APPLICATION NO.	FILING DATE	FIRST NAMED INVENTOR	ATTORNEY DOCKET NO.	CONFIRMATION NO.
09/737,770	12/18/2000	In-Duk Song	8733.339.00	8950
30827 7590 02/28/2006 MCKENNA LONG & ALDRIDGE LLP 1900 K STREET, NW WASHINGTON, DC 20006			EXAMINER	
			RUDE, TIMOTHY L	
			ART UNIT	PAPER NUMBER
			2883	
			DATE MAIL ED: 02/28/2006

<u> </u>	T	A - 1: 4/->			
	Application No.	Applicant(s)			
	09/737,770	SONG, IN-DUK			
Office Action Summary	Examiner	Art Unit			
	Timothy L. Rude	2883			
The MAILING DATE of this communication appears on the cover sheet with the correspondence address Period for Reply					
A SHORTENED STATUTORY PERIOD FOR REPLY WHICHEVER IS LONGER, FROM THE MAILING DA - Extensions of time may be available under the provisions of 37 CFR 1.13 after SIX (6) MONTHS from the mailing date of this communication. - If NO period for reply is specified above, the maximum statutory period v - Failure to reply within the set or extended period for reply will, by statute, Any reply received by the Office later than three months after the mailing earned patent term adjustment. See 37 CFR 1.704(b).	ATE OF THIS COMMUNICATION 36(a). In no event, however, may a reply be tim will apply and will expire

FIG.2E

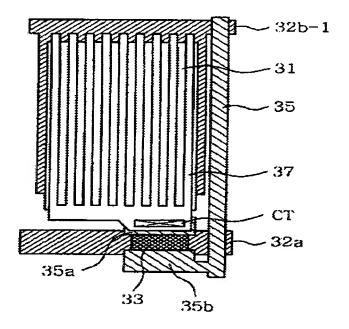
Jeon teaches 1) in Figures 2A-2E, an in-plane switching LCD device comprising: a gate line, 32a, on a first substrate; a data line, 35, on the first substrate, the data line being perpendicular (as illustrated) to the gate line; a common line, 32b-1, on the first

substrate, the common line being parallel (as illustrated) with the gate line and being formed of a metal (Applicant's first material, Cr for both gate line and common line; col. 2, lines 49-58, especially lines 55-58) (Applicant's wherein the common electrode is formed on the substrate like the gate line); a pixel electrode, 37, (ITO; col. 3, lines 18-22) and the common electrode, 31, (ITO; col. 2, lines 64-67) being formed of a transparent conductive material (ITO, Applicant's second material different from the first material); and a liquid crystal layer between the first and second substrates (inherent to comprising a LCD device) made by a method that simplifies the process by reducing the mask number.

Additionally as to claim 17, as combined above, Jeon discloses in Figures 2A-2E, in-plane switching Liquid Crystal Display (LCD) device, comprising: a first substrate and a second substrate a gate line, 32a, on the first substrate; a metal common line, 32b, (Cr for both gate line and common line; col. 2, lines 49-58) on the first substrate, the common line parallel (as illustrated) to the gate line, a data line, 35, on the first substrate, the data line being perpendicular (as illustrated) to the gate line; a common electrode, 31, on the first substrate; a thin film transistor having a gate electrode, a

Additionally as to claim 18, Jeon, as combined above, discloses the LCD device of claim 17, wherein a portion of the common line overlies a portion of the common electrode (Figures 2A-2E, especially Figure 2C, and col. 2, lines 49-67, especially lines 64-67).

FIG. I

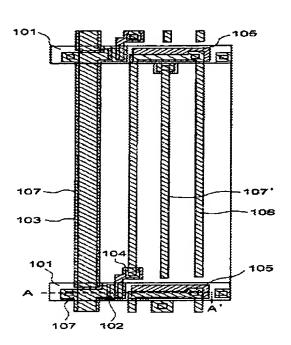
Ando teaches 2) [col. 6, line 29 through col. 8, line 46] a storage capacitor, 105, over the common line, 101, and between the pixel electrode and the first substrate, wherein the storage capacitor contacts the second connecting line, 106, via a contact hole per Figures 1 and 2 in order to comprise his invention for an in-plane switched LCD with improved aperture ratio [abstract].

FIG. 3

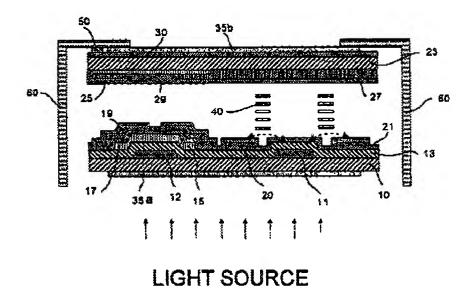
Son teaches in Figure 3, an LCD device, further comprising a light-shielding layer, 25, (Applicant's black matrix) on the second substrate, 23, (para 0029).

Son is evidence that ordinary workers in the art of liquid crystals would find the reason, suggestion, or motivation to use a black matrix on the second substrate to prevent light from leaking around the TFT (first two lines of para 0029).
